# Access Compliance Report

## Public Rights-of-Way

### (Curb Ramps)

Intersection ID: 2874	Main Street: HORNBEAM_CT	Cross Street: LADY_BANK_DR	Location: SE
ADA ID: 2035A570A7E0	Ramp Type: Perp	Initial Pass/Fail: Fail	Overall Compliance: No
Codes/Mitigation Info/Possible Solution		Field Measurements/Component Compliance	
Severity Score: 10

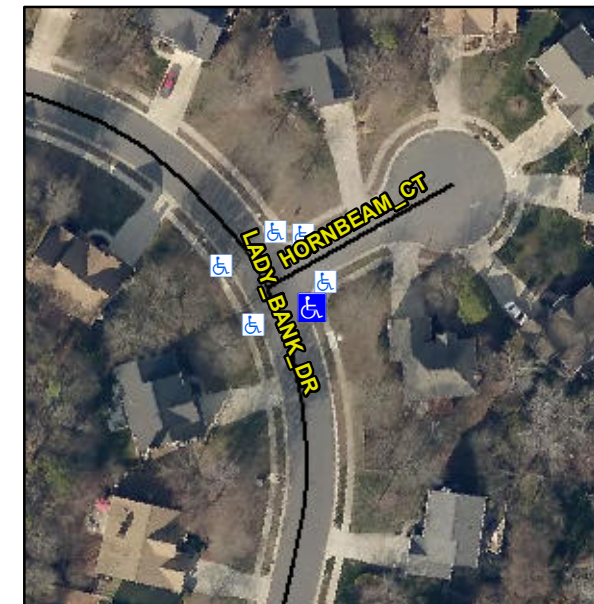
**Remove & Replace Entire Ramp.**

**R304.5.1, R304.5.3**

Compliance	Description	Data	Compliance	Description	Data
N/A	Ramp Length (in)	48.0	Yes	Ramp Slope (%)	6.7
No	Ramp Width (in)	38.0	No	Ramp XSlope (%)	2.9
N/A	Flare Type LT	N/A	N/A	Flare Type RT	N/A
N/A	Flare Slope LT (%)	N/A	N/A	Flare Slope RT (%)	N/A
N/A	Flare Traversable LT?	N/A	N/A	Flare Traversable RT?	N/A
N/A	Landing Length (in)	N/A	N/A	DWS Provided?	N/A
N/A	Landing Width (in)	N/A	N/A	DWS Contrast?	N/A
N/A	Landing Slope (%)	N/A	N/A	DWS Length (in)	N/A
N/A	Landing X Slope (%)	N/A	N/A	DWS Full Width?	N/A
N/A	Landing Curb? (Y/N)	N/A	N/A	DWS Offset (in)	N/A
N/A	Shared Landing?	N/A			
N/A	Gutter Ponding?	N/A	N/A	Gutter Slope (%)	N/A
N/A	Gutter Lip Ht (in)	N/A	N/A	Gutter X Slope (%)	N/A
N/A	Painted X Walk1?	No	N/A	Painted X Walk2?	N/A
	X Walk 1 Direction	To W		X Walk 2 Direction	N/A
N/A	X Walk 1 Width (in)	N/A	N/A	X Walk 2 Width (in)	N/A
	X Walk 1 Slope (%)	6.6		X Walk 2 Slope (%)	N/A
	X Walk 1 X Slope (%)	0.2		X Walk 2 X Slope (%)	N/A
